Appendix E:
Correspondence with MTCS

**Reference: Amherst Island Wind Energy
Project Layout Modifications**

Reference: Amherst Island Wind Energy Project Heritage Assessment – Project Layout Modifications

Reference: Amherst Island Wind Energy Project Protected Properties – Project Layout Modifications

Attachment: Project Location & Study Area: Proposed Modifications

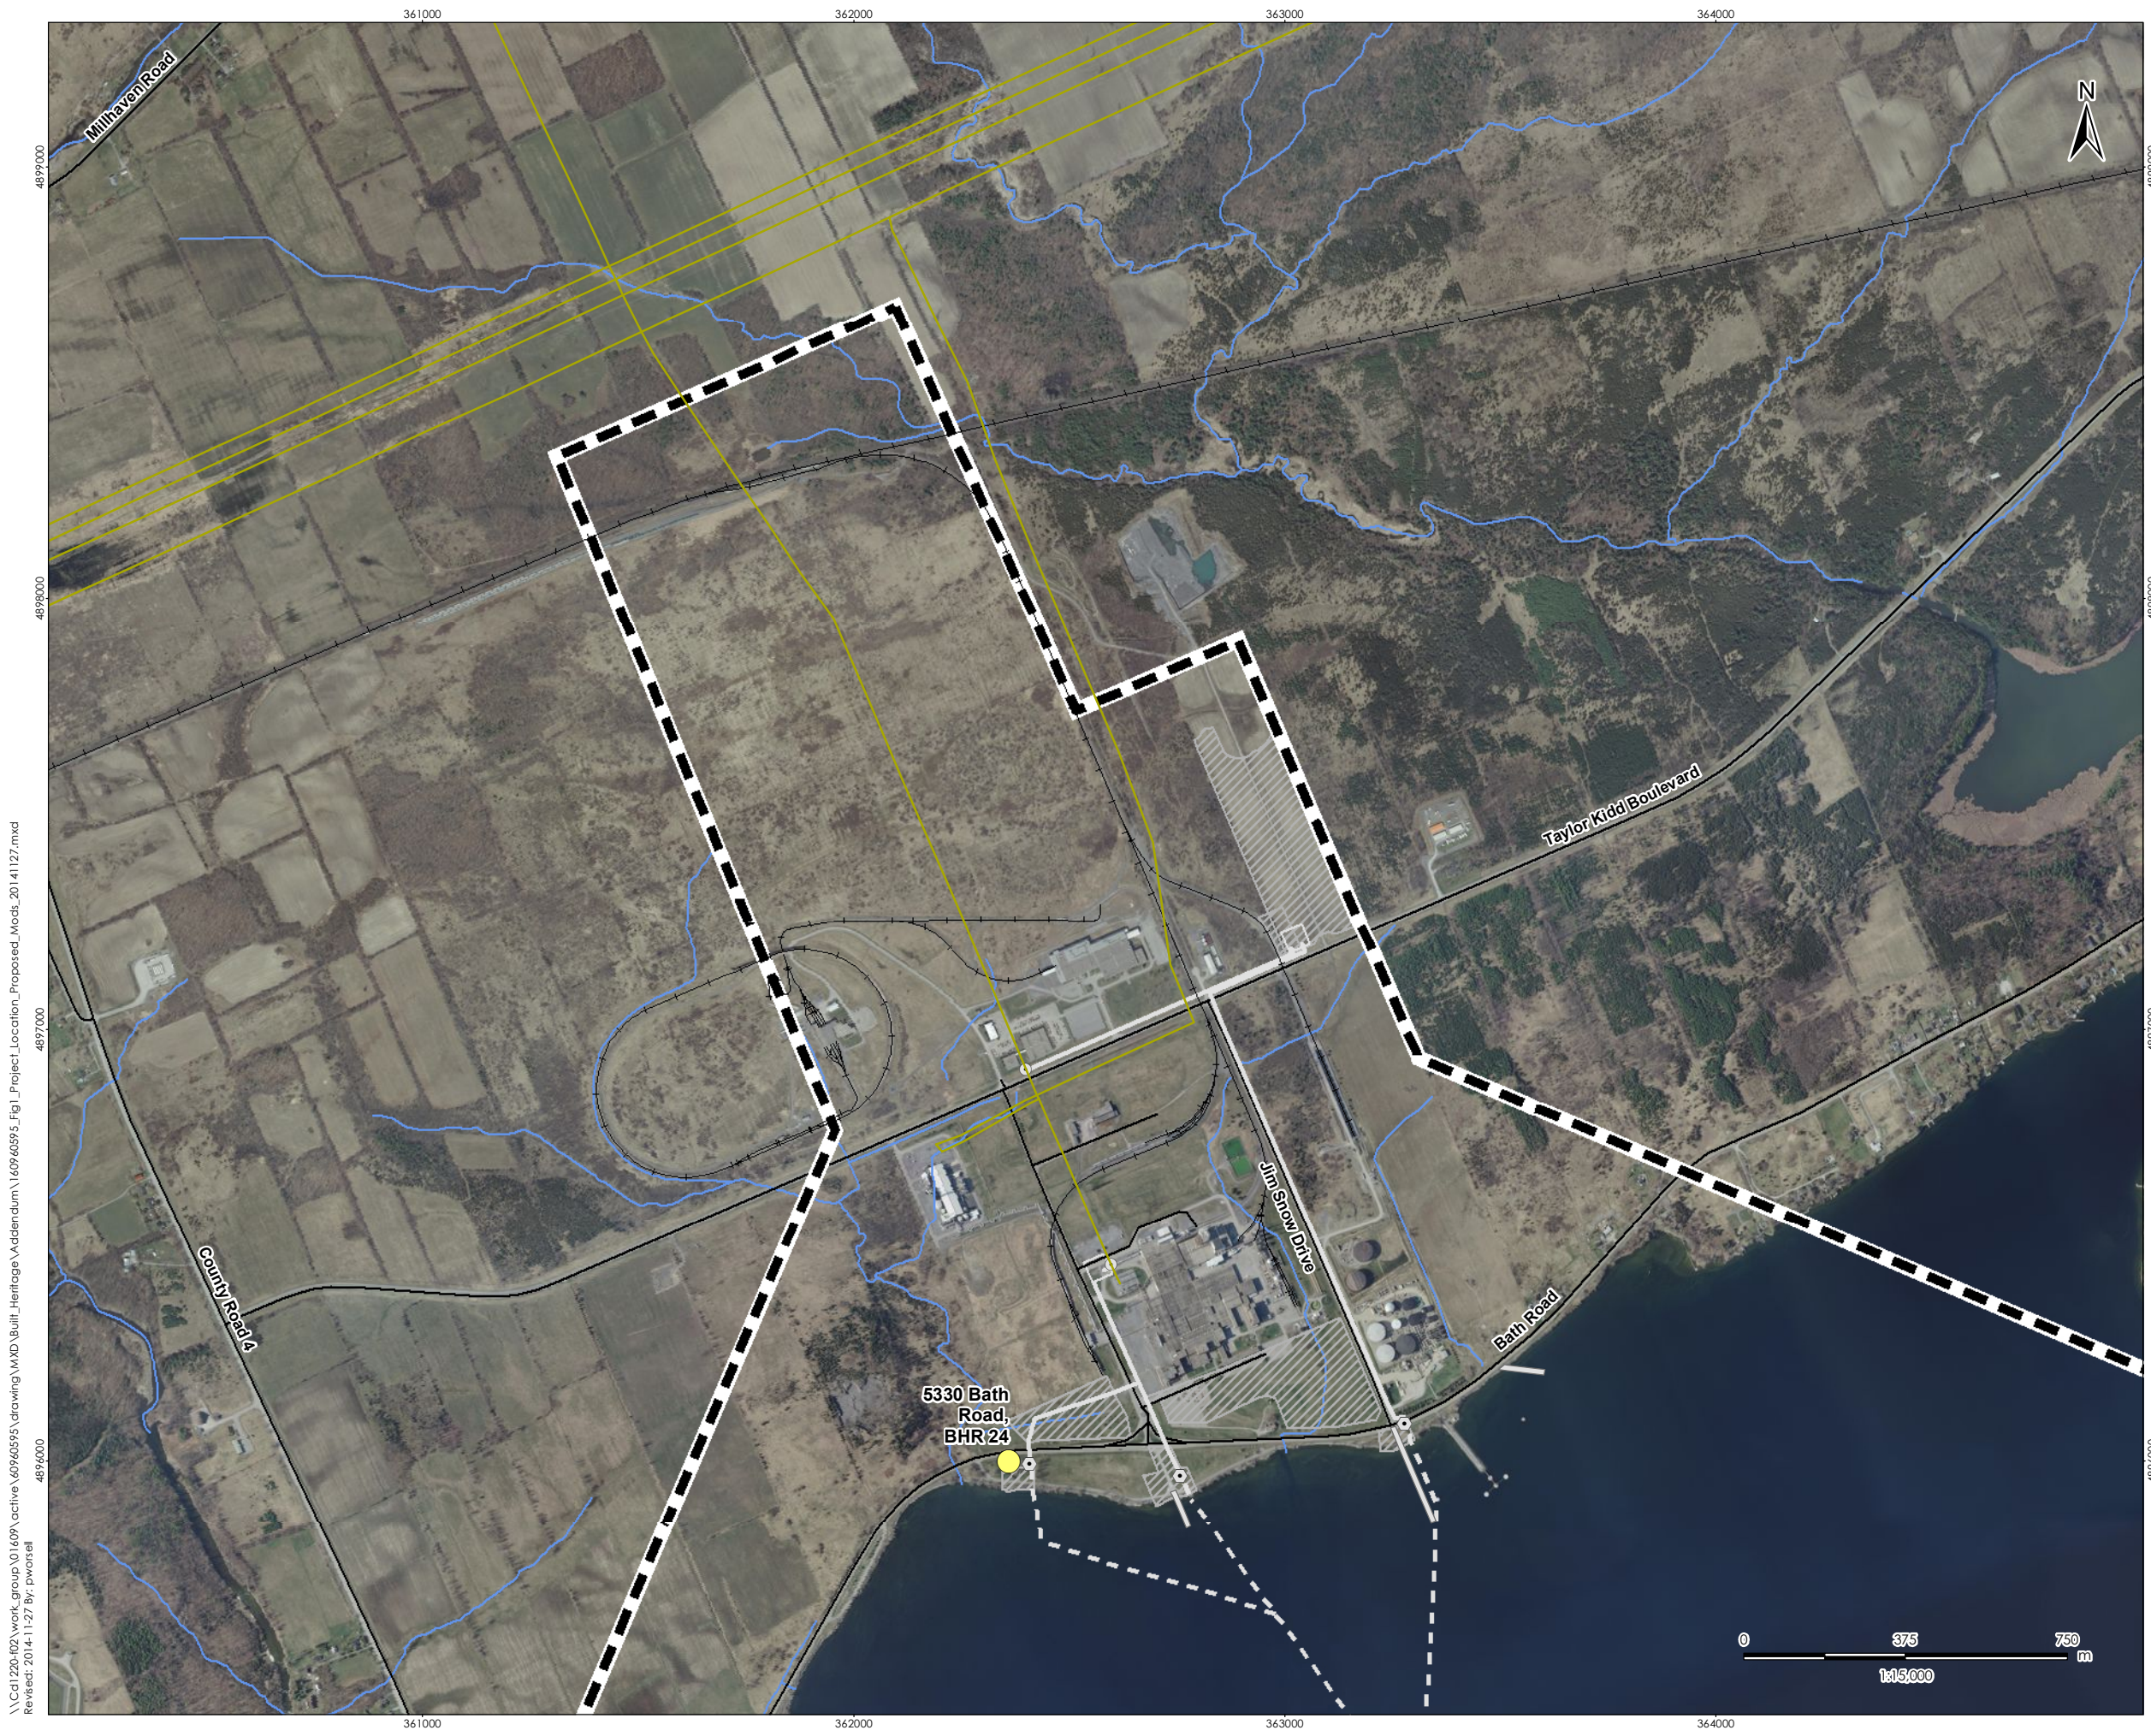
There are three modifications which have been proposed following the completion of the *Protected Properties Assessment*. These are: (1) a change in turbine model and associated reduction in the number of turbines, (2) a change in collection system routing to avoid the Village of Stella and (3) changes to the road and collection system to avoid some activities on 2nd Concession.

This modification involves changing the Project's turbines from a combination of Siemens 2.3 MW and 2.221 MW to a combination of Siemens 2.942 MW and 2.772 MW, and thereby reducing the number of turbines from 36 to 27. The new turbines would be physically identical, specifically with a hub height of 99.5 m and rotor diameter of 113 m. The modification will decrease the Project Location size by reducing the number of turbine sites from 36 to 27. All of these 27 turbine sites are in previously studied and proposed locations.

2. Collection System Route Change 1 – Avoiding the Village of Stella

This proposed modification would involve rerouting the collection system to avoid the Village of Stella. In doing so, this modification would remove a significant portion of the existing collection system from S30 entrance along Front Road, including by removing approximately 4 km of road allowance trenching (including through Stella). The modification would also require a new collection corridor from S13 to South Shore Rd. and west to S14 entrance, which would consist of approximately 1 km in road allowance and 700 m of in pasture field. The modification will decrease the Project Location size by resulting in a net reduction of approximately 2 km of collection system trenching.

3. Collection System Route Change 2 – Reducing Impacts on 2nd Concession

This modification would involve the addition of an underground collector line along a previously approved access road between T16/T23 and T35. The collector line has been incorporated into the design of the access road between T16/23 and T35. The modification will decrease the Project Location size by eliminating the need to install a second collection circuit trench on approximately 3 km of 2nd Concession.
